From: Katie Jones [kjones@riceswd.com]
Sent: Friday, April 01, 2011 3:07 PM
To: Hansen, Edward J., EMNRD
Cc: Hack Conder; Katie Lee
Subject: Vacuum L-26 vent (1R425-66) CAP Addendum
Attachments: Vacuum L-26 vent (1R425-66) Proposed Liner.jpg; Vacuum L-26 vent (1R425-66) IC Report and CAP 9.14.10.pdf

This email is an Addendum to the Vacuum L-26 vent site (1R425-66) Initial Characterization Report and Corrective Action Plan (CAP), submitted to the NMOCD on September 14, 2010. Page 3, section: Recommendations, paragraphs 1-3: text in blue lettering, below, will replace text in red lettering, below. A new plat showing the proposed liner dimensions and the previously submitted Initial Characterization Report and CAP are attached. If you need any further information, please let me or Hack know.

Vacuum L-26 vent

Case #: 1R425-66

Proposed liner

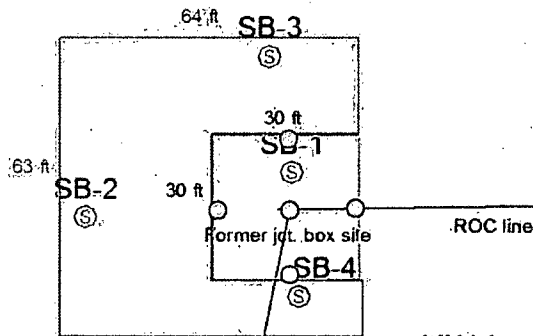
To further protect groundwater from potential chloride migration, ROC proposes to excavate soil with a 64x63-ft area to a depth of approximately 5 to 4-ft below ground surface (bgs) and properly seat a 20 mil, reinforced polyethylene liner in the base of the excavation. Backfill soils will not exceed a chloride concentration of 500 mg/kg and a PID (field) ready of 100 ppm. Excavated soil will be evaluated for use as backfill and any soil requiring disposal will be properly disposed of at a NMOCD approved facility. The site will then be seeded with native seed mixes and soil amendments will be added as necessary to encourage re-vegetation. As plants capture water through their roots, they reduce the volume of water infiltrating below the root zone and create a natural "infiltration barrier" that will remain in place after the buried synthetic liner degrades. Both the synthetic liner and vegetation help protect ground water as the decreased flux of water through the subsurface slows the transportation rate of residual chloride in the subsurface, allowing dilution and dispersion to decrease possible adverse impact to ground water.

"A monitoring well (MW-1) was installed approximately 50 feet down gradient of this site on November 15, 2010. Groundwater samples collected from this monitoring well tested 940 mg/L and 960 mg/L Cl⁻ on November 22, 2010 and February 16, 2011, respectively. ROC proposes to install additional monitoring wells to further delineate groundwater quality at this site.

Once these activities are completed and ROC has obtained three quarters of monitoring well sampling data on the additional wells, we will submit a CAP Report on the findings regarding groundwater quality and a summary of the corrective actions."
